# We are proposing a change in your area

<b>Reference</b>	TR121-21 Evans Bay Parade, Wellington – Cycle Lanes; Bus stops; Give way/Stop; Pedestrian crossing; Time Limited parking; NSAAT
<b>What we'd like to do</b>	<p>We propose to construct a two-way bike path and separate footpath along the western side of Evans Bay Parade, replacing the existing shared path. This project will result in changes to some areas that are currently used for on-street parking, including:</p> <ul style="list-style-type: none"><li>• rearrangement of on-street parking – there will be new parking spaces available in some places, and many spaces removed in others.</li><li>• new timing restrictions in some areas</li><li>• removal of three bus stop pairs</li><li>• new pedestrian crossings</li></ul> <p>More information about the parking changes can be found in the Parking Management Plan.</p>
<b>Why we are proposing the change</b>	<p>This proposal is about completing Tahitai, the walking and bike connection from the east. Planning started about five years ago with drop-in sessions at the ASB sports centre, a community working group, community consultation, and a 2018 Council decision and vision to develop this

Me Heke Ki Pōneke

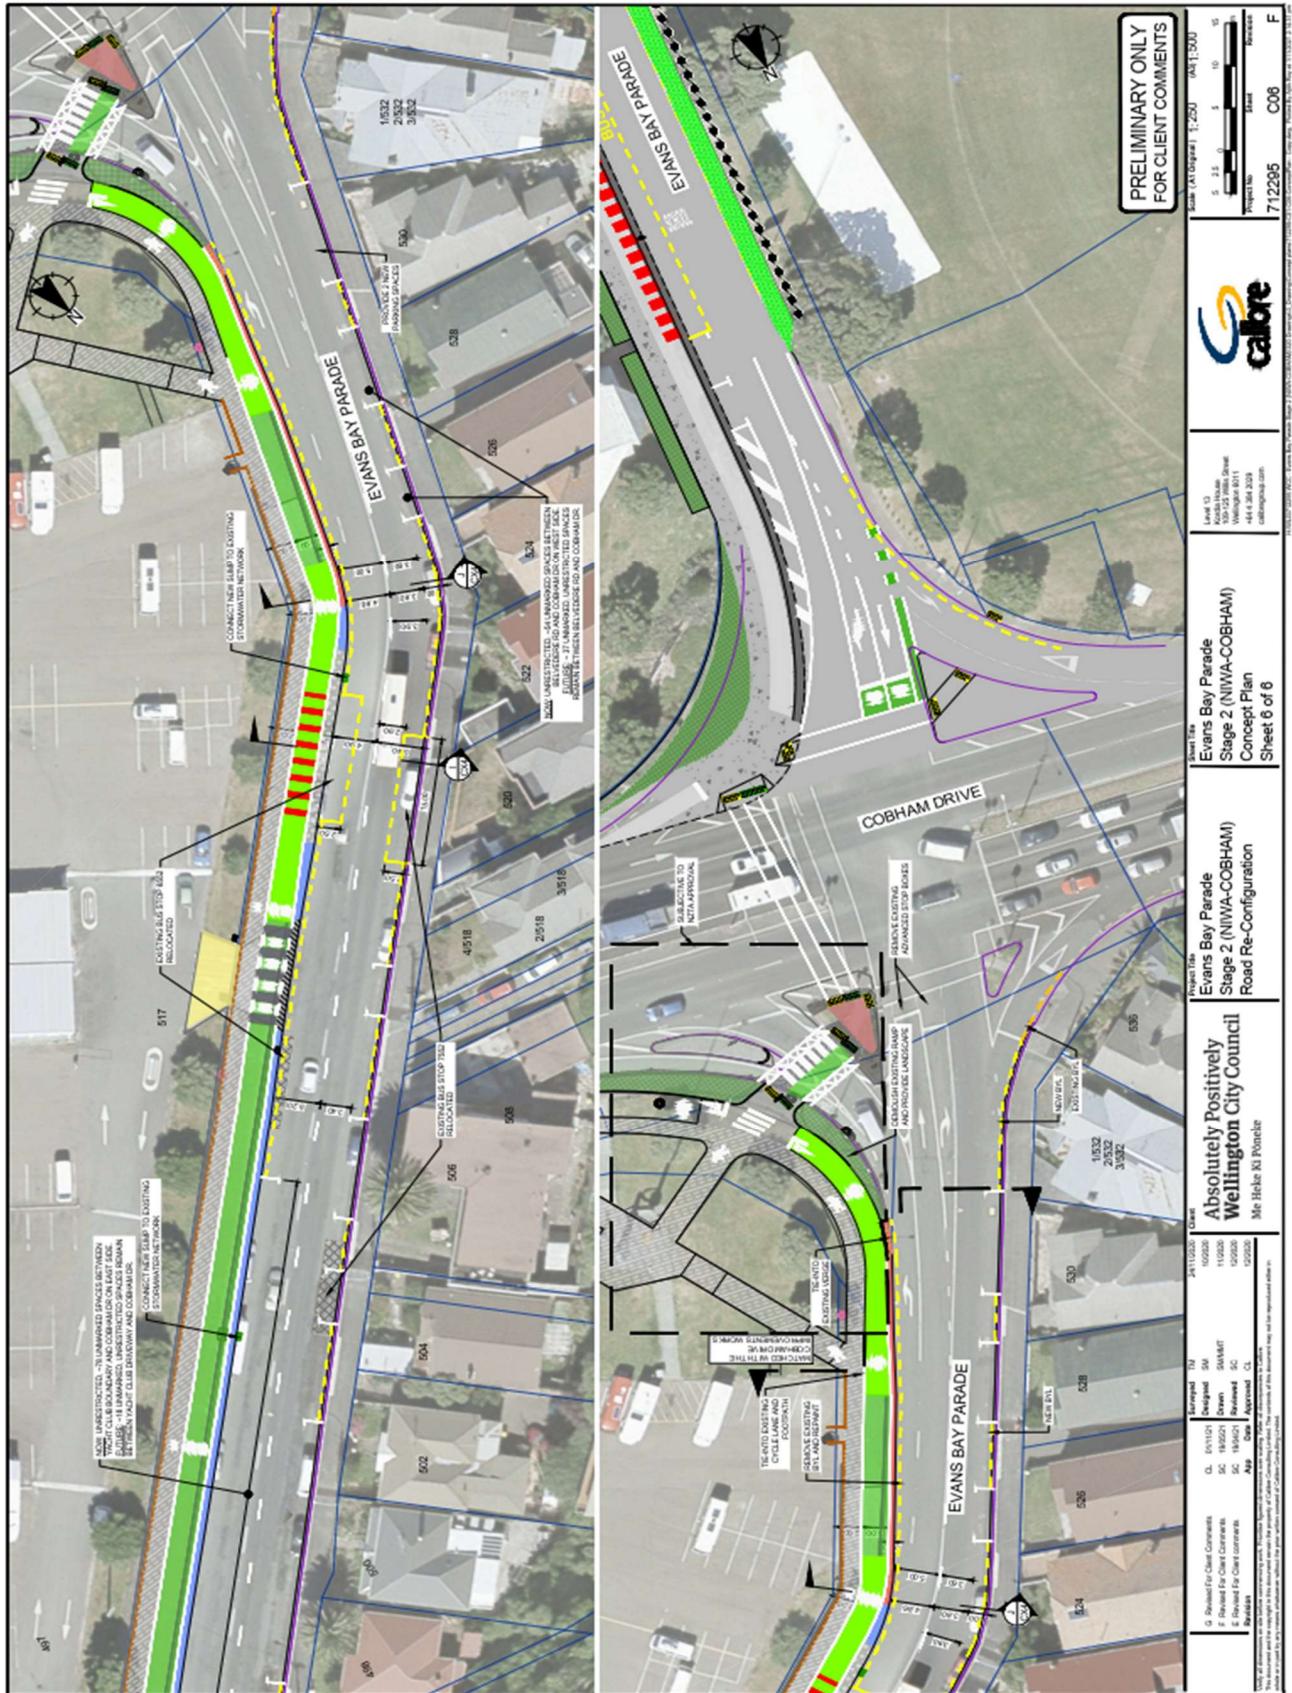
<p>A total of 1,032 responses were received. 63% of submissions support or strongly support the proposals. 33% oppose or strongly oppose. 22 of the submissions were on behalf of an organisation.</p> <p>The key theme of the opposition was the removal of on-street car parking, particularly adjacent to Hataitai beach, the boat sheds and the Evans Bay Yacht and Motor Boat Club. Those that undertake water-based recreational activities were most likely to oppose the project.</p> <p>There was also a significant number of constructive comments on what could be changed to improve the designs. Some of these have been taken on board and will be considered in more detail during the detailed design stage of the project.</p> <p>Officers propose the following changes in response to public feedback</p> <ul style="list-style-type: none"><li>• An extra 13 on-street car parking spaces being reinstated due to minor space reallocation through minor traffic lane and/or bike path narrowing<ul style="list-style-type: none"><li>○ Two adjacent to the boat sheds on east side of road</li><li>○ Four opposite boat sheds on west side of road</li><li>○ Two opposite Yacht Club on west side of road</li><li>○ Two opposite public boat ramp on west side of road</li><li>○ Three opposite southern end of marina on west side of road</li></ul></li><li>• An extra two on-street car parking spaces opposite Hataitai beach created by building into the reserve, proposed to be P15 to facilitate drop-off and pick-up</li><li>• Optimisation of the space available at the public boat ramp to provide more parking for recreational visitors to the area, particularly for water-based activities.</li><li>• Relocation of pedestrian crossing near to Greta Point Café to a location further north, resulting in four additional car parking spaces</li><li>• Conversion of one on-street car parks to provide an additional mobility parking spaces at Greta Point (P90)</li></ul> <p>These changes are reflected in the Traffic Resolution below.</p>

Red text indicates a change or an addition from the traffic resolution that went out for consultation.

Strikethrough text indicates where a proposed change has been removed from the traffic resolution that went out for consultation.
